CURTAIN WALL DETAILS BHF 0169 (09)

CURTAIN WALL DETAILS
BHF 0169(09)
CHELSEA, VERMONT

SHEET NUMBER
7
OF 11

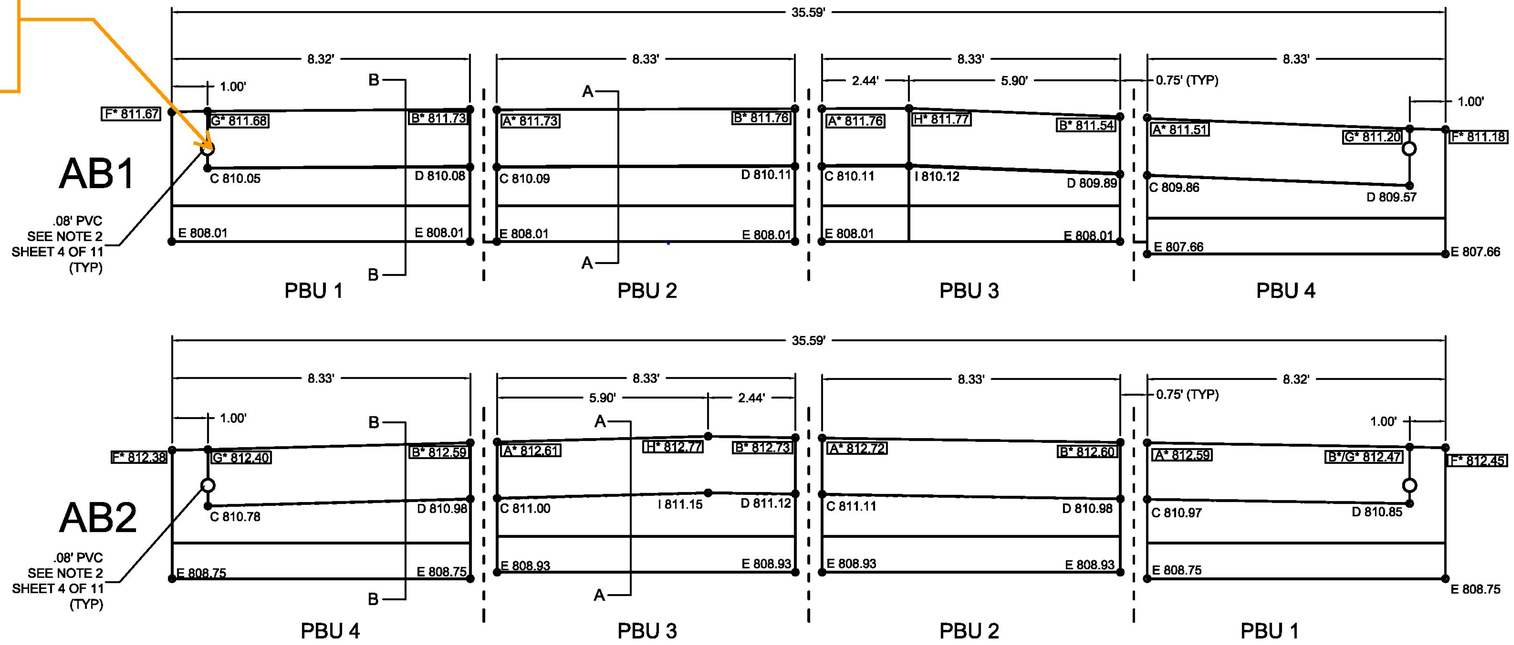
this will conflict with installation of the approach slabs. suggest moving it outward 6". (typ)
